NEW MEXICO
ENVIRONMENT DEPARTMENT

Hazardous Waste Bureau

**RE: NOTICE OF DISAPPROVAL: DOE/SANDIA RESPONSES TO NMED'S
NOTICE OF DISAPPROVAL FOR CORRECTIVE MEASURES EVALUATION
REPORT FOR TECHNICAL AREA-V GROUNDWATER, JULY, 2005
SANDIA NATIONAL LABORATORIES
EPA ID# NM5890110518
HWB-SNL-05-027**

As Appendix A of the response, the Permittees submitted: *Technical Area V Groundwater Investigation Work Plan, Installation of Groundwater Monitoring Wells TAV-MW11, TAV-MW12, and TAV-MW13, Installation of Soil-Vapor Monitoring Wells TAV-SV01, TAV-SV02, and TAV-SV03*, dated April, 2009 (hereinafter referred to as the Work Plan). NMED has the following comments regarding the Work Plan.

Figure 2. TAV-MW1/10 TCE and Nitrate.

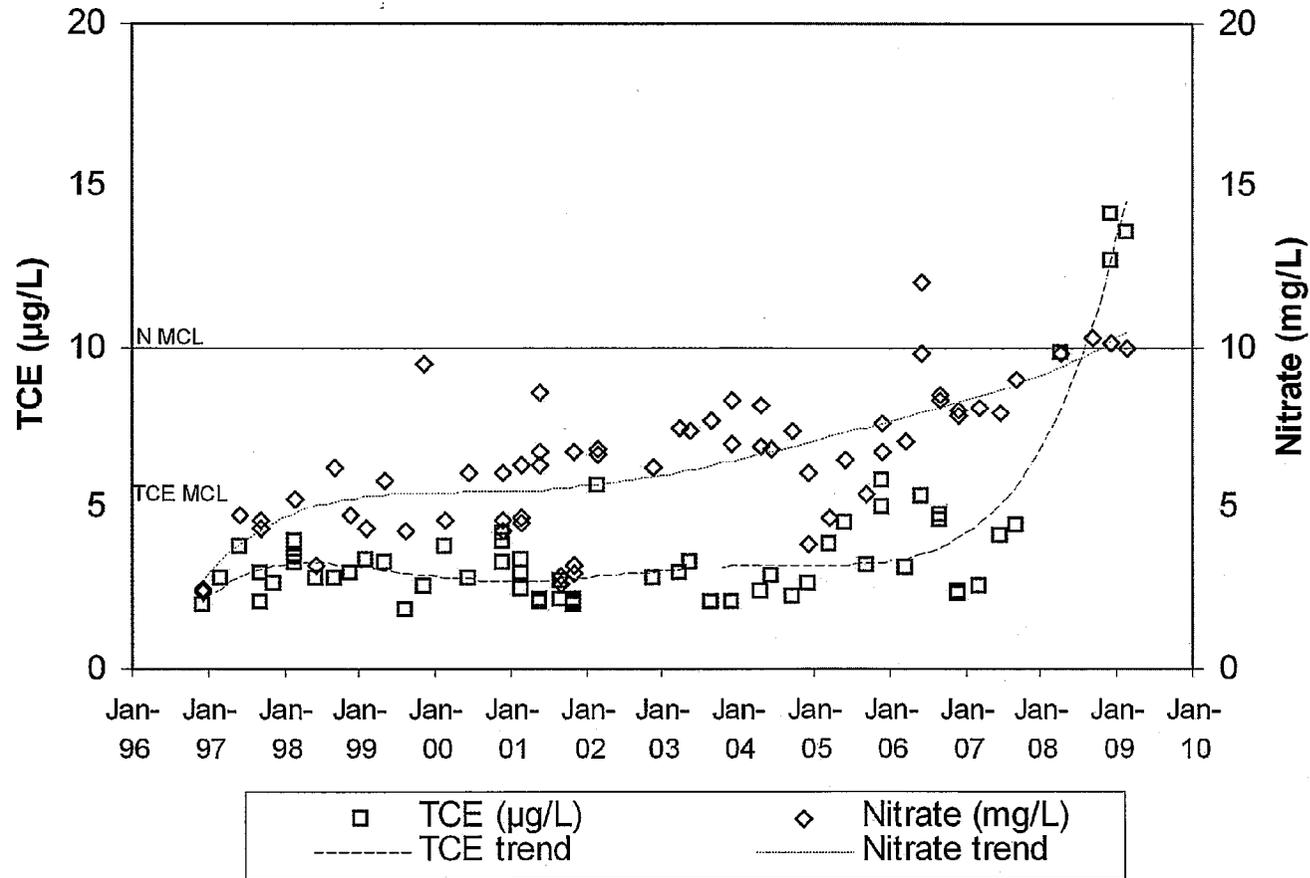
Groundwater at TAV-MW10 exhibits TCE above the maximum concentration limit (MCL) and has an increasing nitrate-concentration trend suggesting that nitrate levels are beginning to exceed the MCL (see Figure 2 enclosed with this letter). This well can therefore no longer be used to delineate the outline of the plume (i.e., the area of the plume where concentrations are below MCLs). Another well is needed to characterize the plume in this area of Technical Area – V (TA-V). Even if groundwater samples from TAV-MW11 and TAV-MW12 are nondetect with respect to TCE and nitrate, TAV-MW10 would show the plume outline is not resolved. A suggested location for this additional well is shown in Figure 1 of this letter.
